Planning Division
15151 E. Alameda Parkway, Ste. 2300
Aurora, Colorado 80012
303.739.7250

Re: Initial Submission Review – Waterstone Site Plan No 4 – Site Plan and Plat
Application Number: **DA-1758-10**
Case Numbers: **2021-4016-00**

Initial Submission Review

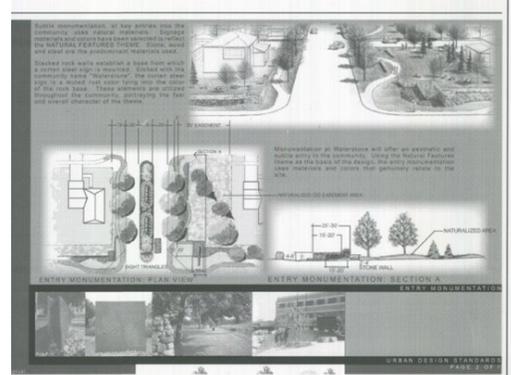
- 2A. Since the neighborhood activity center (NAC) is no longer in the code, please relabel as a private park. Please also indicate whether the park meets the minimum size of 7 acres. The total acreage noted in the Master Plan is 10.68 acres.
- 2B. Please note the park in Planning Area 2 must be fully constructed prior to the 100th Certificate of Occupancy in Planning Area 1. Please add a note
- 2C. On Sheet 2, please enlarge the Site Plan notes.
- 2D. Please provide a lot typical illustrating setbacks.
- 2E. What is the purpose of the empty box on Sheet 6?
- 2F. Please reach out to ECCV and provide their comments with the next submission.
- 2G. Please update the data table to look similar to the graphic to the right. Please refer to the Site Plan Manual if you need additional detail.
